# Groundwater Monitoring Plan

## Corrective Action Management Unit (CAMU) Area

December 16, 2008

**Appendix A**  
**Responses to Nevada Division of Environmental Protection Comments dated**  
**November 13, 2008, regarding Groundwater Monitoring Plan (October 28, 2008)**  
**Corrective Action Management Unit (CAMU) Area**  
**NDEP Facility ID# H-000688**

FIGURE D-20

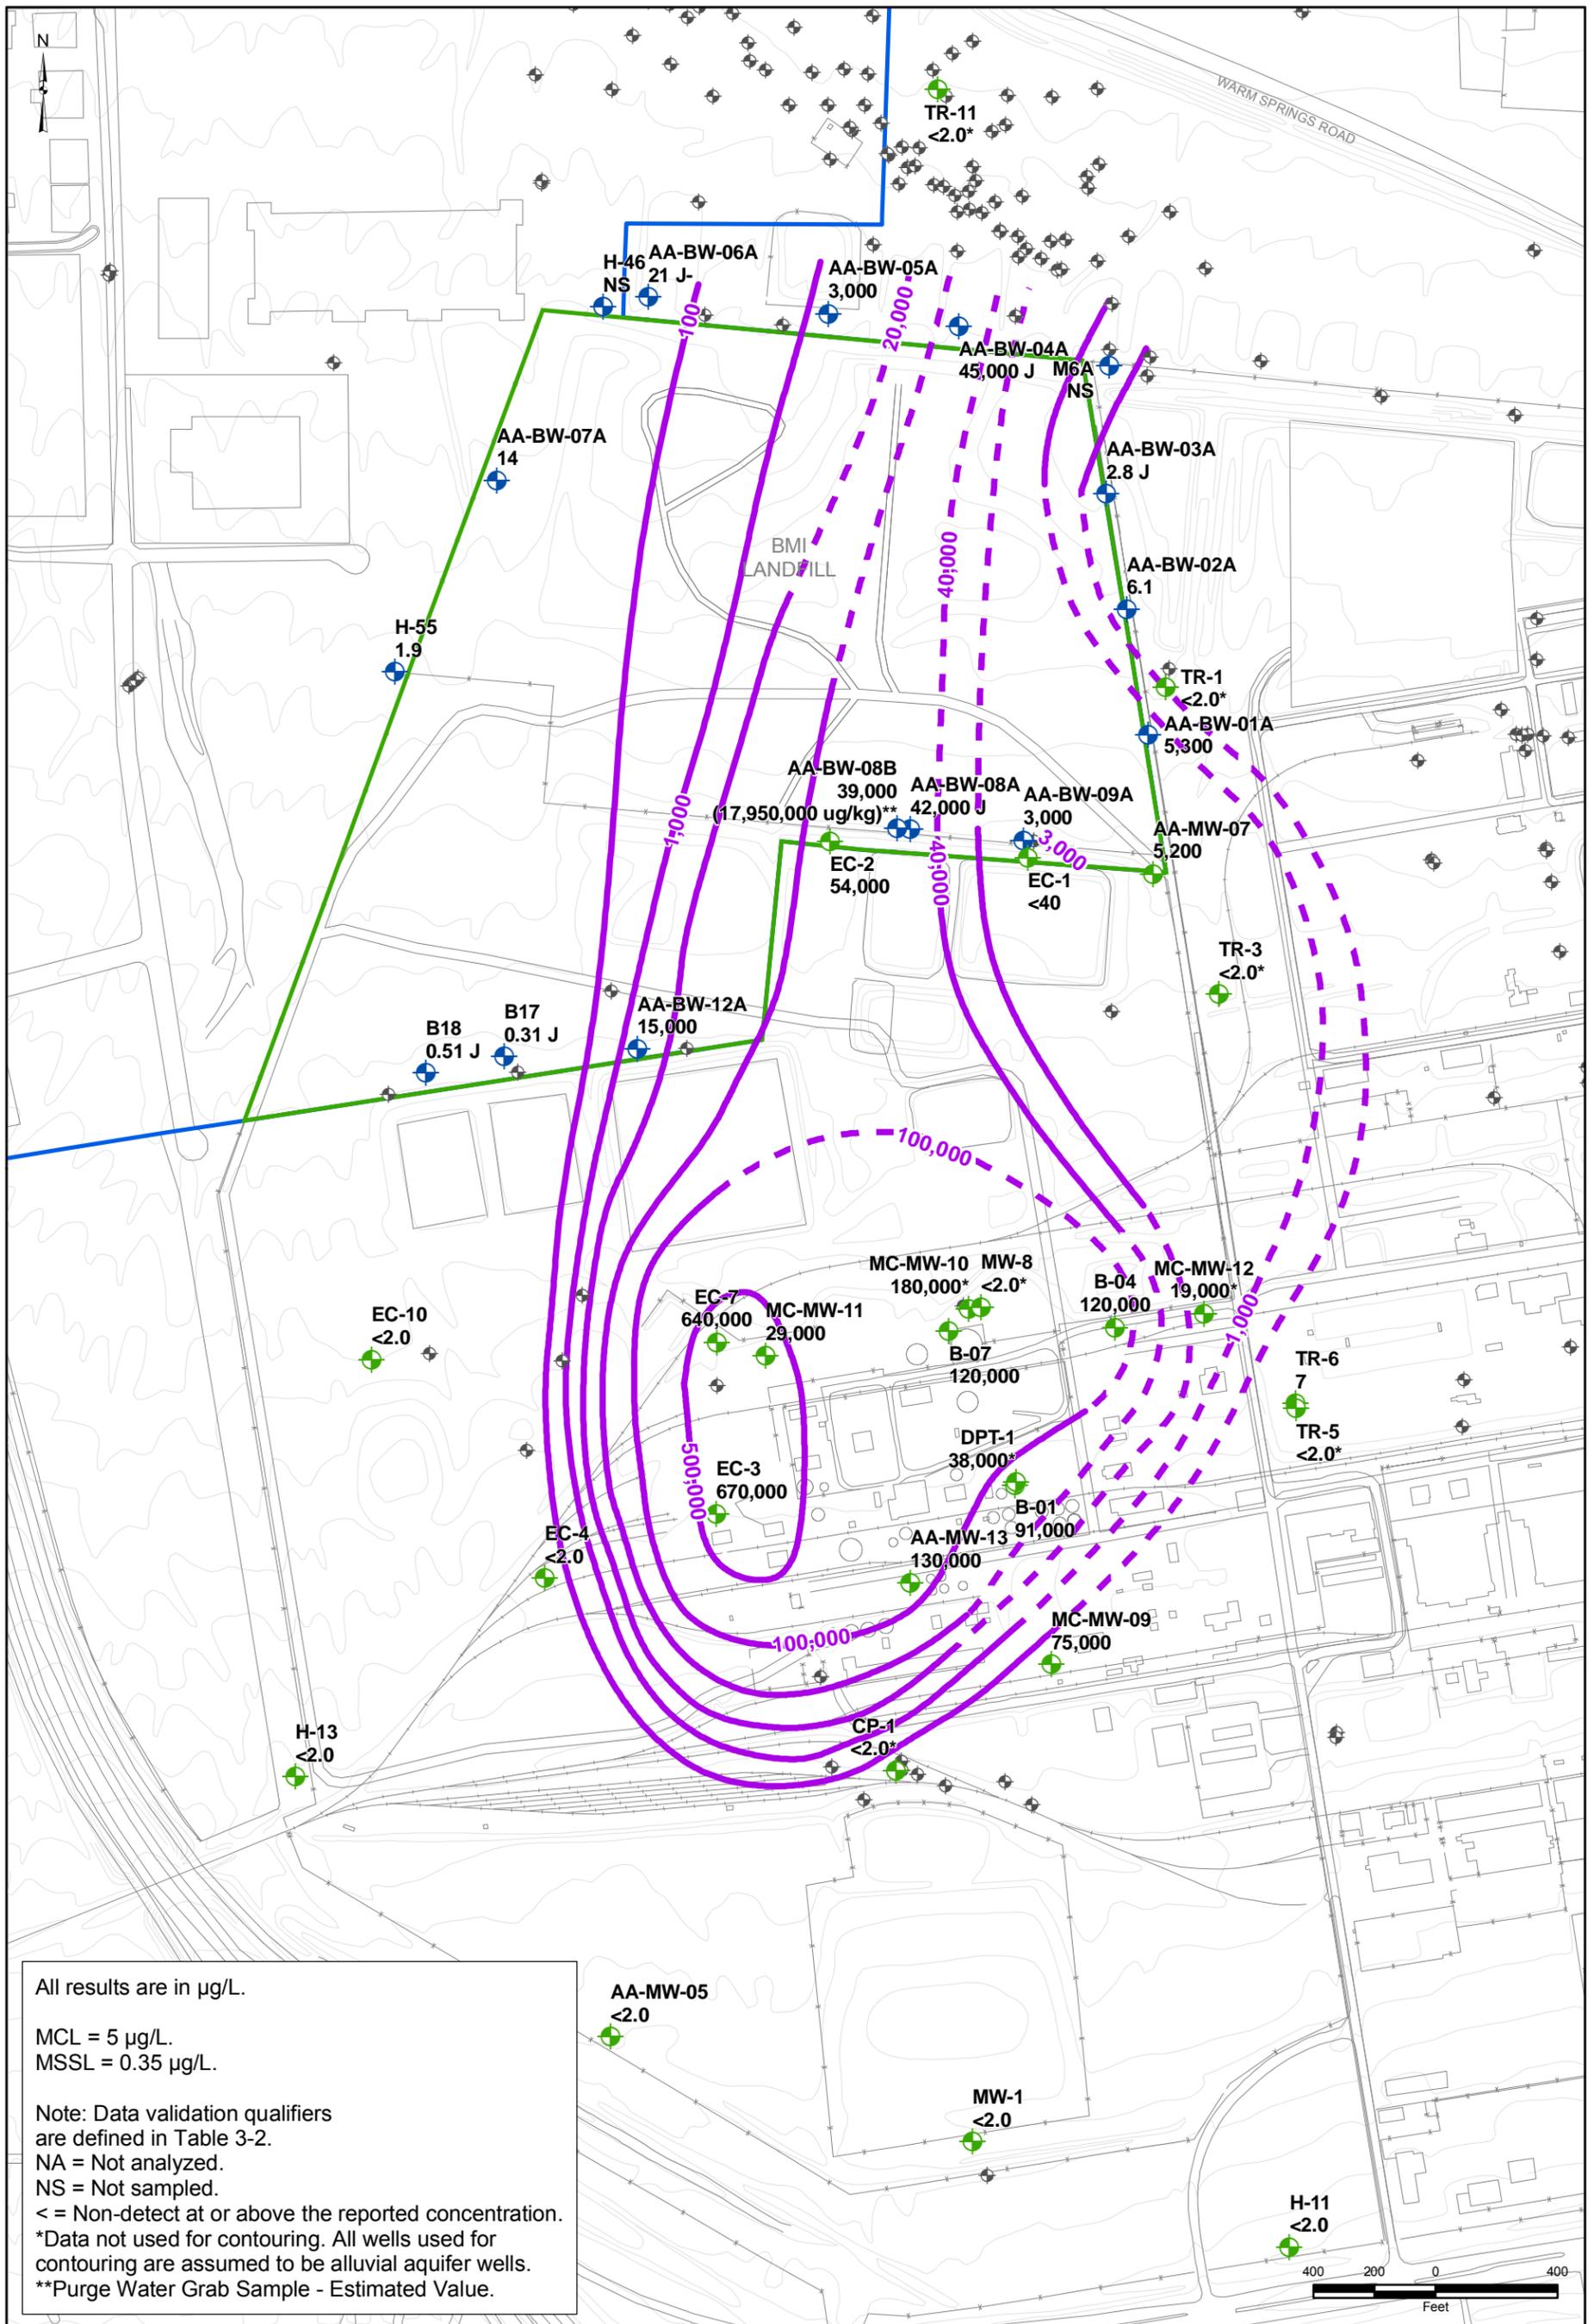
25. Figure D-4, -7, and -20, what is the rationale for excluding some data for the purpose of contouring?

**Response:** The figures plot data for the Shallow Zone, so data for wells screened in the Middle Zone or the Deep Zone were excluded from the contours. The excluded wells were retained on the figures solely for reference.
